City of Sugar Hill  
Addendum to Planning Staff Report  
**RZ 16-002**

**DATE:** July 07, 2016  
**TO:** Mayor and City Council  
**FROM:** Planning Director  
**SUBJECT:** Change in Conditions RZ 16-002 – Bellagio Properties

RE: Proposed Grocery Store by Bellagio Properties  
RZ 16-002  
W&A Job Number 16-CE-008

City of Sugar Hill  
Planning Staff Report  
RZ 16-002

**Z-1**

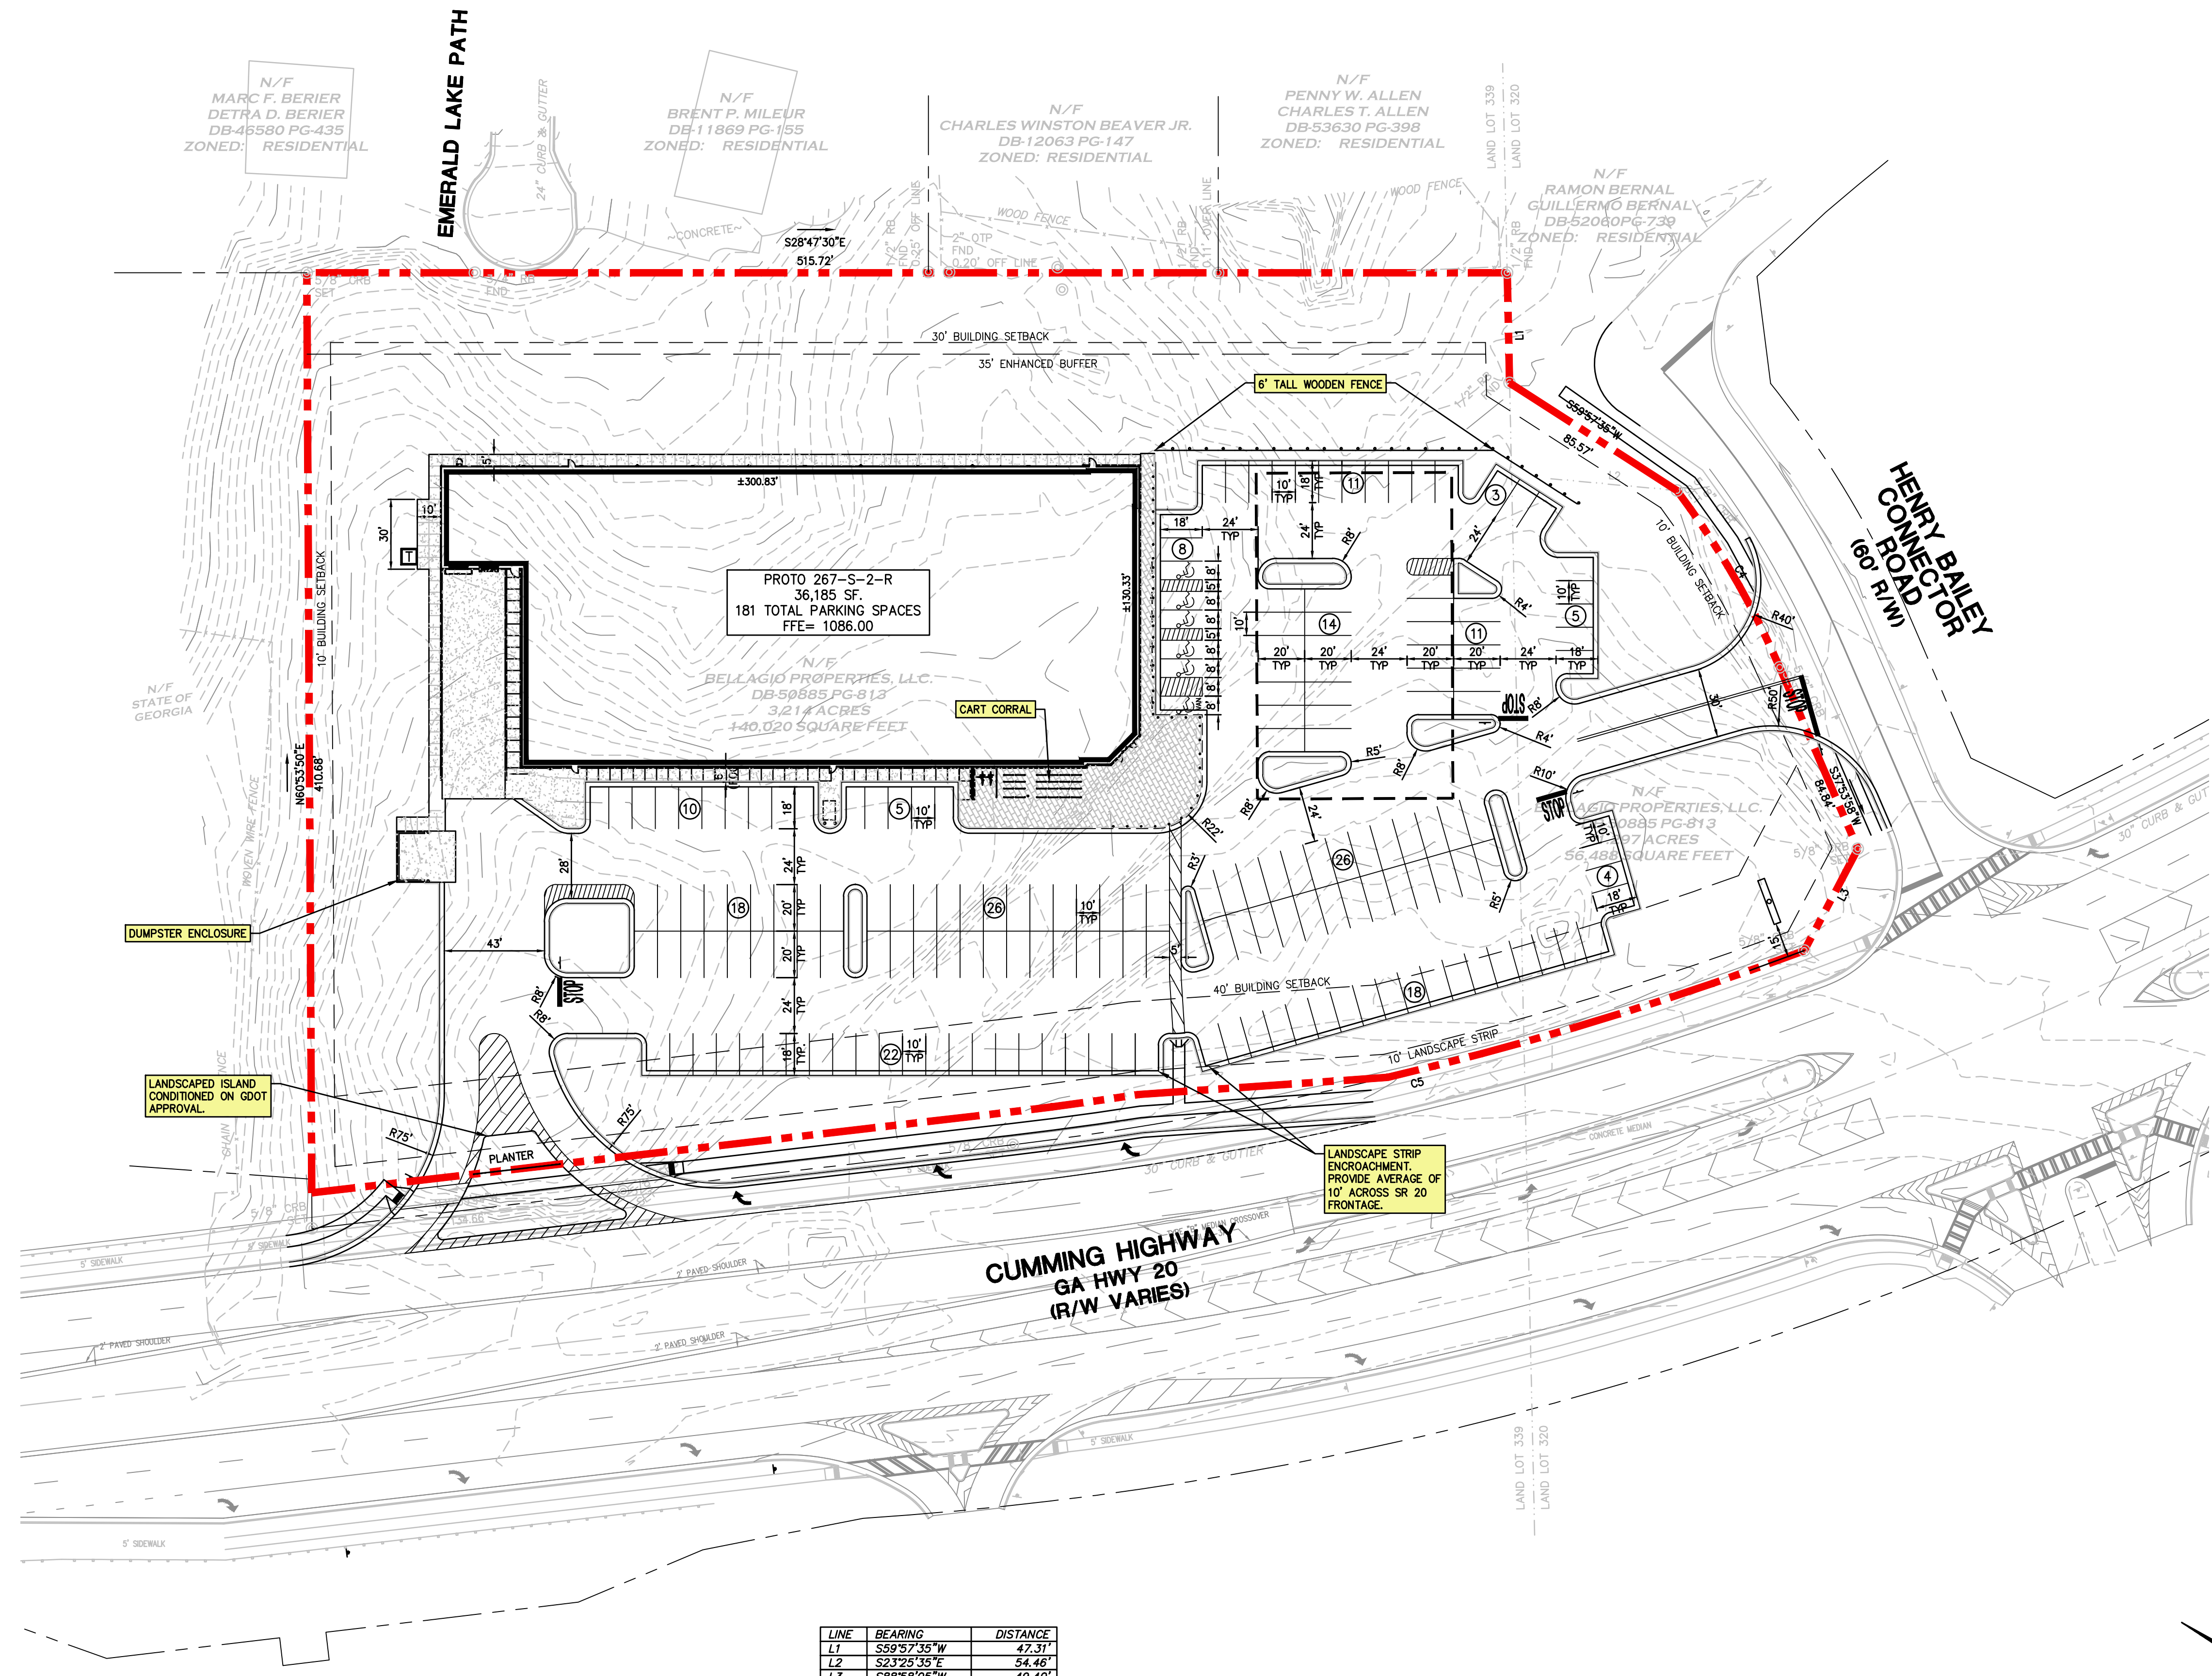
- The location of the loading dock and dumpster do not meet the zoning ordinance requirements and face SR 20 and the front driveway entrance to the parking lot.

5. *The location of the dumpster enclosure and loading dock are approved per the site plan by W&A dated 6/3/16 provided the approval of the Landscape Plan by David Albright, dated 6/8/16.*

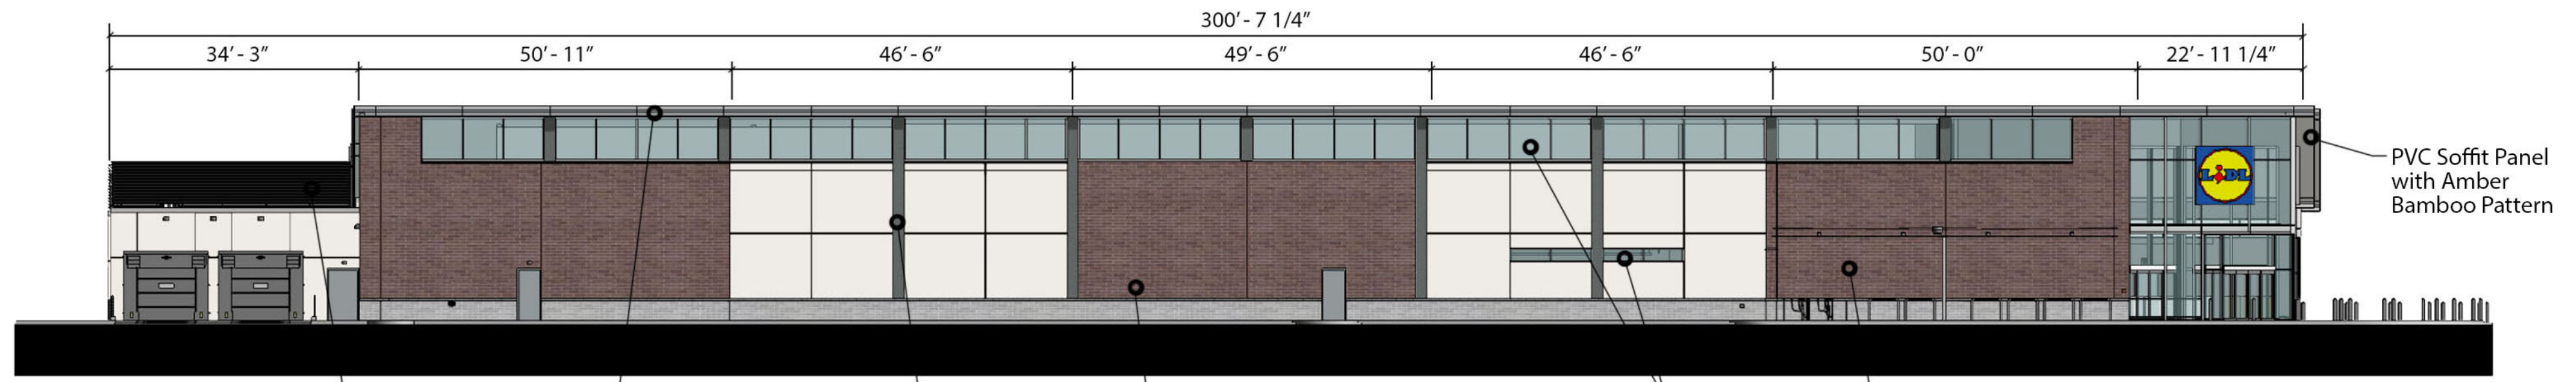
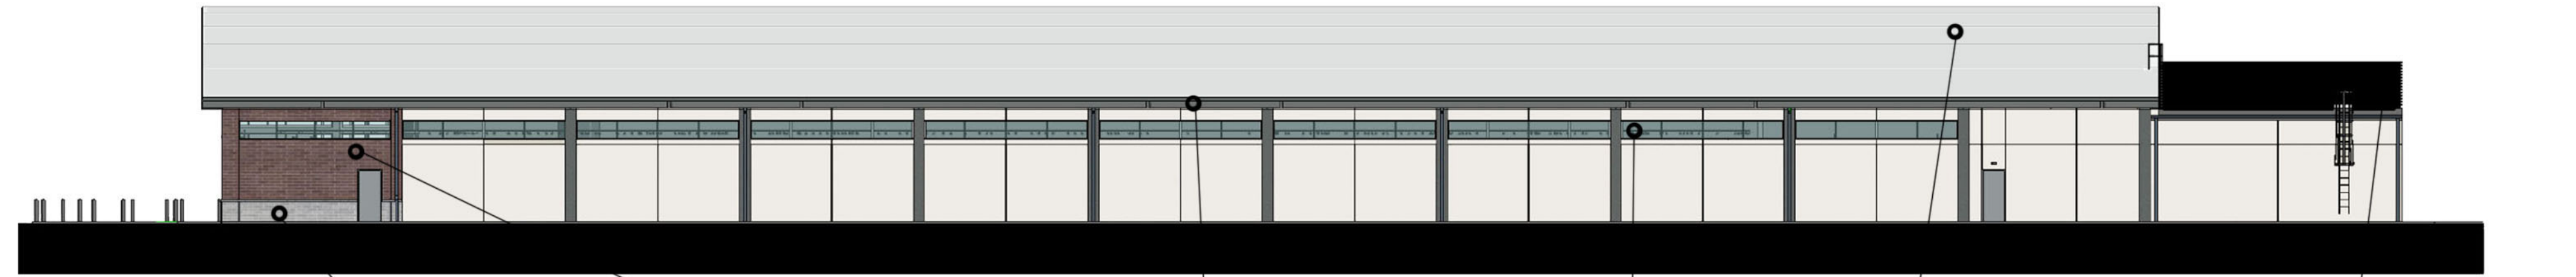
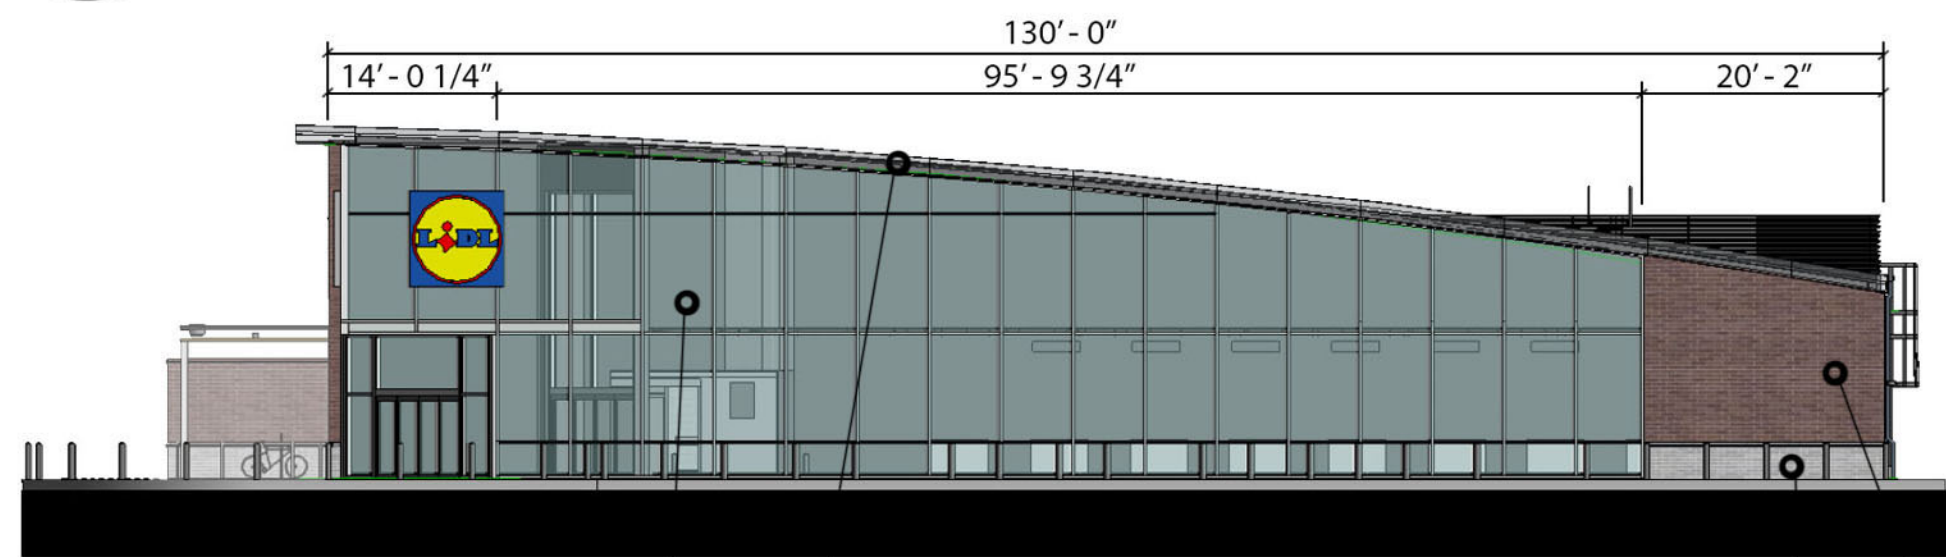
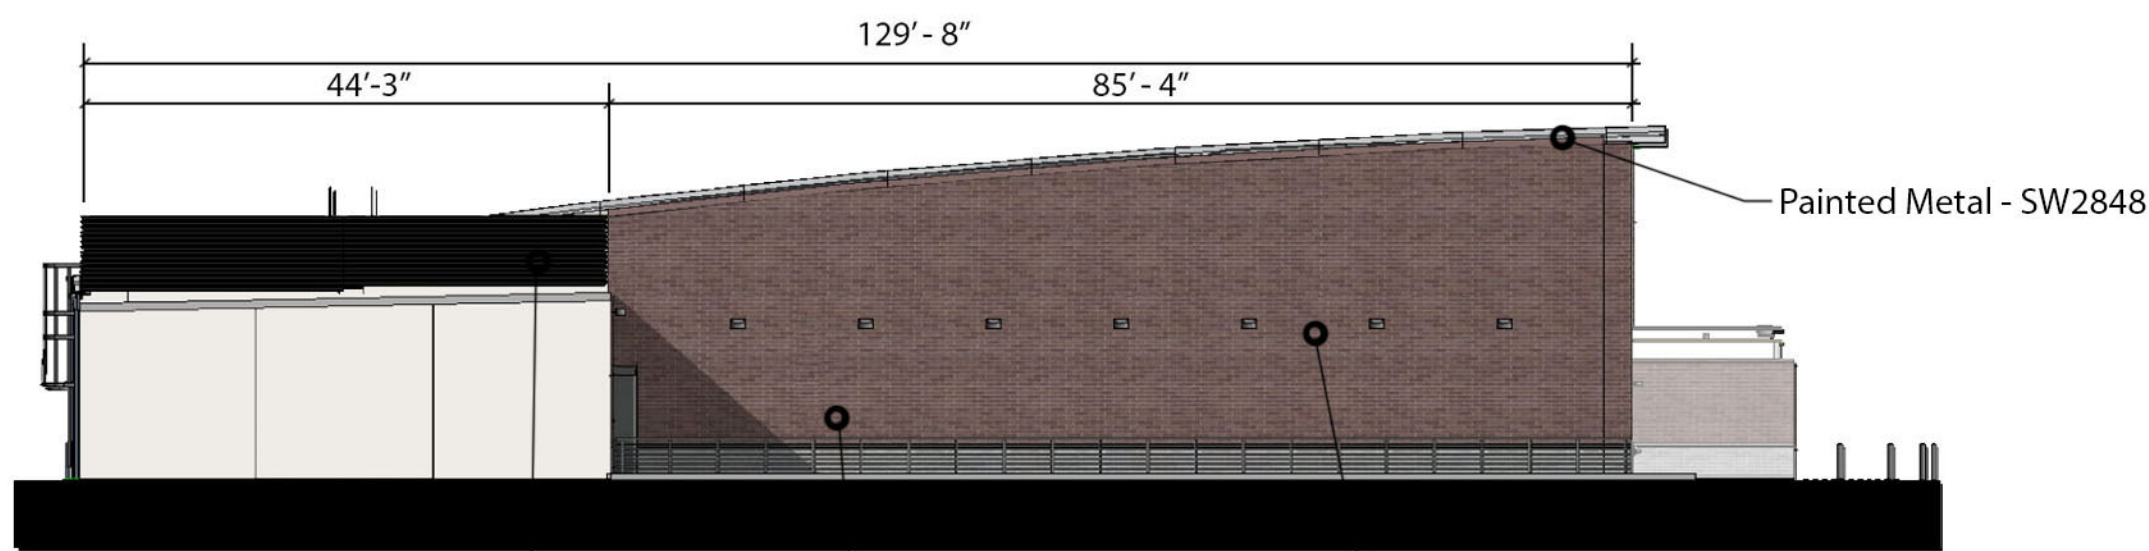
- No supporting documentation has been provided by the applicant for removing the requirement to screen the grocery cart corral area.
- The provided elevation does not comply with the architectural design standards in the following ways:

- More than two primary building materials have been used (from Sugar Hill Zoning Ordinance, page 6.9, "With the exception of accent/trim materials, there shall be no more than two primary building materials used.")

- Use of a glass curtain wall (from Sugar Hill Zoning Ordinance, page 6.9, "Mirrored glass with a reflection greater than 20% and glass curtain walls shall be prohibited.")

- Use of a façade segment greater than allowed. On both the east and west elevations, the total length of the façade is approximately 130'. An unbroken brick facade segment that is 85'-4" in length has been used on the west elevation, and an unbroken glass façade that is 95'-9 3/4" has been used on the east elevation (from Sugar Hill Zoning Ordinance page 6.9, "Building facades shall be visually divided into segments through articulation of the façade achieved by methods such as, but not limited to, variation in building materials, roof line, building setback, the use of additional window bays, pilasters, etc." The chart on this page shows that for 50'-150' length facades, the maximum segment length is 50')

- Staff has additional concerns regarding the quality of the building elevations presented.
  - The overall horizontality of the building elements (clerestory windows, column bays, change in materials, etc) and lack of architectural elements on the pedestrian level does not relate well to a human scale.

- Overall, the building lacks substantially in ornamentation and detail. At the pedestrian level, the façade is mostly blank with very few windows or architectural detailing to attract interest (from Sugar Hill Zoning Ordinance, page 6.9, “These guidelines shall foster architectural diversity and interest, yet achieve and maintain a consistent, durable and pleasing aesthetic/visual quality.”)

- The building does not display a clear hierarchy between service space and served (public) space. Due to the siting of the building on a corner lot, there are effectively two front facades (south and east). The south elevation (facing SR 20) includes a loading dock, service doors, and clerestory windows with a small amount of glazing located around 8-10’ height). The east elevation is primarily composed of a curtain wall. (from Sugar Hill Zoning Ordinance, page 10.12, “...utility/service areas shall be screened and incorporated into the design of the building and/or hidden from public view when viewed from any public space or street level.” And from Sugar Hill Zoning Ordinance, page 6.6 “Roll-up type cargo bay doors shall be limited to the side or rear of buildings located in OI, HSB, and BG zoning districts.”)

- The stucco elements on the south elevation appear to read as columns; however, they do not penetrate the Urban Gray brick to the ground and in several locations are only located on the clerestory window portion and therefore appear to read as joists. The spacing and regularity between these two elements are not regular, and the function and/or aesthetics of these architectural elements are unclear. (from Sugar Hill Zoning Ordinance, page 6.6, “Each building design shall be made up of a compatible combination of these traditional architectural elements or similar elements...prominent columns, posts, and/or pilasters...”)

- As these stucco elements and joints in brick walls do not effectively divide the building into segments, this does not appear to meet the intent or spirit of the requirement within the zoning ordinance to visually divide facades into segments.
